#2 Belt Conveyor Disturbed area expansion TS-13 & TS-5 amendment Submittal,
Castle Valley Mining, LLC, C/015/0025

Title: TS-5 & TS-13 Amendment

Modify TS-13 & Commit to coal clean up on TS-5

BEAR CANYON | PLATE 2-3F

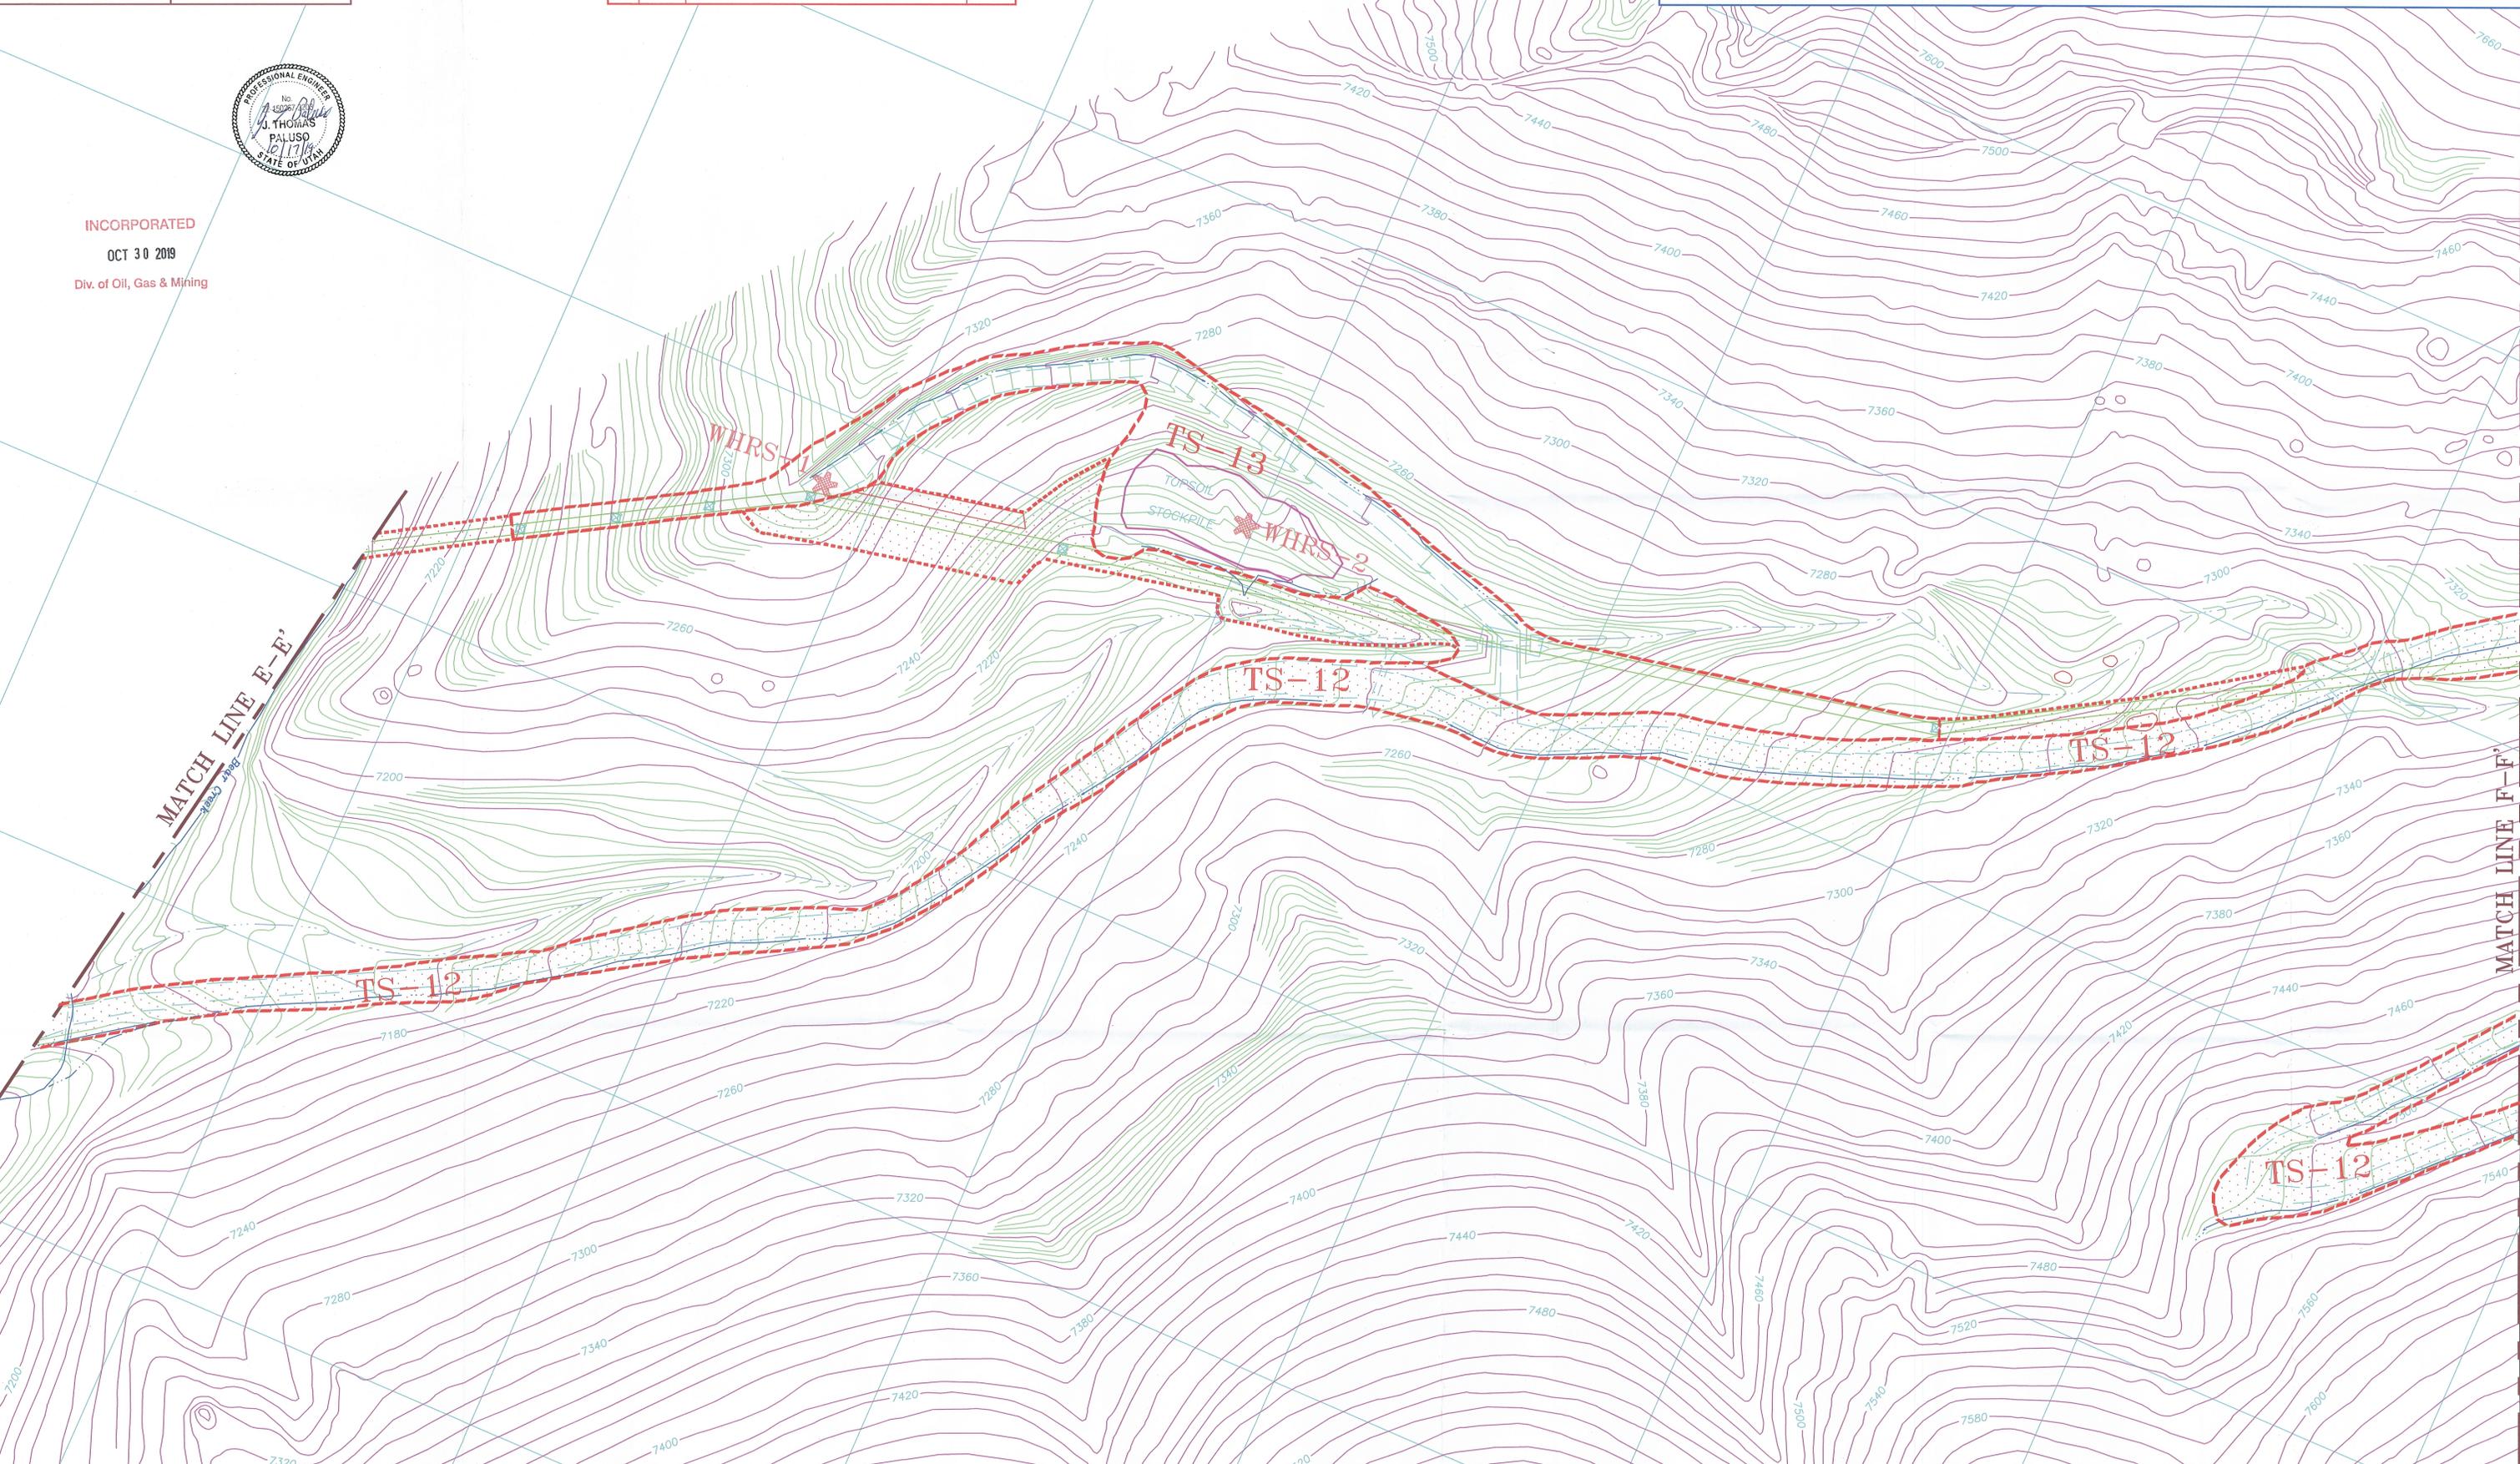
REV.	DATE	REMARKS	APPR.
1	8/01/02	Changed name from 8-5F to 2-3F	12/8/05
2	10/11/19	Revised disturbed area boundary	
3			
4			
5			
6			
7			
8			
9			
10

This area modified 10-11-2019 to reflect the modification of an expansion of disturbed area boundary located on [Plate 2-3F](#). Belt conveyor spillage frequent in this area and will be cleaned up upon 4" or more coal spillage weather permitting. South side boundary line will be lined with

straw bales to contain any coal spillage. Area too steep to recover any topsoil. Straw wattles will be placed where needed on the slope to prevent erosion. This area including expansion will be revegetated upon final reclamation.
